## Architectural Review Committee Meeting – Follow-up August 27, 2025

**4:00 p.m. Smith Entertainment Group “SEG” Phase 3 – Macey’s Building Remodel project (10450 S. State Street), Larry Oldham, Rob Cottle (Babcock Design), Jim Olson (Utah Jazz)**

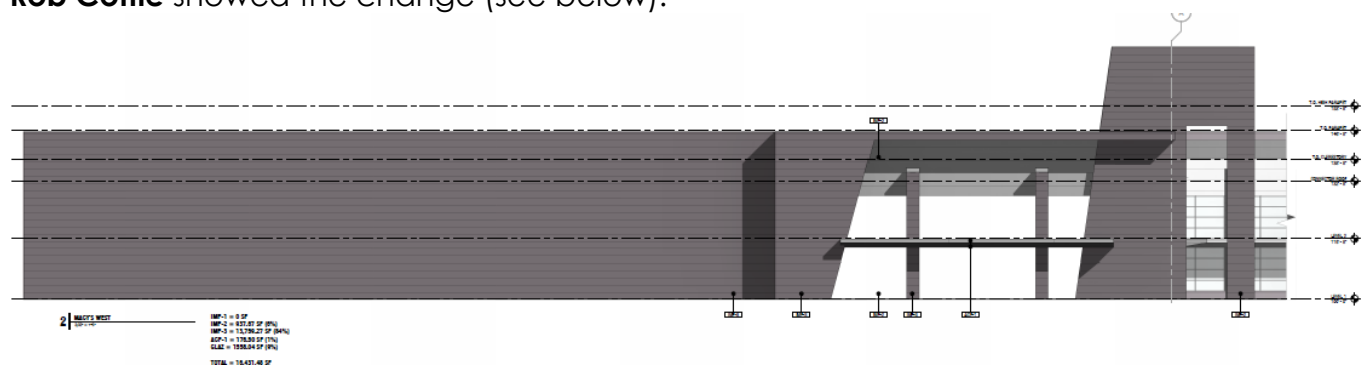
**Mike Wilcox** asked if the perforated metal material is a new material that has been added to these plans.

**Doug Wheelwright** asked why they went away from doing the pylon on the southwest corner.

**Rob Cottle** said yes and that this would sit out from the glass two to three feet and help with the solar shading. They would also use this element for some branding, using logos within the panel itself.

**Rob Cottle** said that the pylon blocked some of the view and took up half of a building bay (wall section). They wanted the glass to be a more prominent element to the pro shop so you could tell it was a store. They also wanted the signage to be obvious for the patrons coming in. Also, Rob wanted us to know that Ryan Smith, the owner, had concerns that the pylon would block patrons knowing where the retail store was. He wanted to make sure that this space would be obvious to see and find.

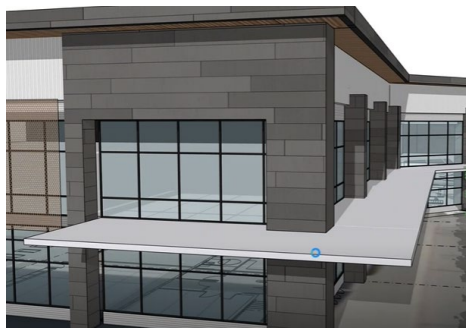
**Mike Wilcox** asked if they could show the previous elevation that was previously approved by this committee as well as the Planning Commission.

**Steve Burt** commented on the amount of glass on the west side and how they would be able to deal with that heat gain.

**Steve Burt** asked if the roof will have internal roof drains.

**Mike Wilcox** stated how staff liked the canopy that goes around the southwest corner, which was hard to see on the updated plans (see canopy below).

**Doug Wheelwright** said that they are pleased with what they have been shown, but they are still concerned about the loss of the corner pylon. Doug asked if there was any interest in taking either the southwest corner dark gray material, or the central employee entrance dark gray material, and extending it up through and above the roof parapet.

**Rob Cottle** showed the change (see below).

**Rob Cottle** stated that their intention on the current south and west sides of the building will use a solar coating, and they will have some glazing around the icebox as well. So, they are using the performance of the glass as well as the static physical shading.

**Rob Cottle** said there are roof drains, and that the roof drains down behind the fascia.

**Rob Cottle** said that the canopy will help bring attention to the corner retail shop.
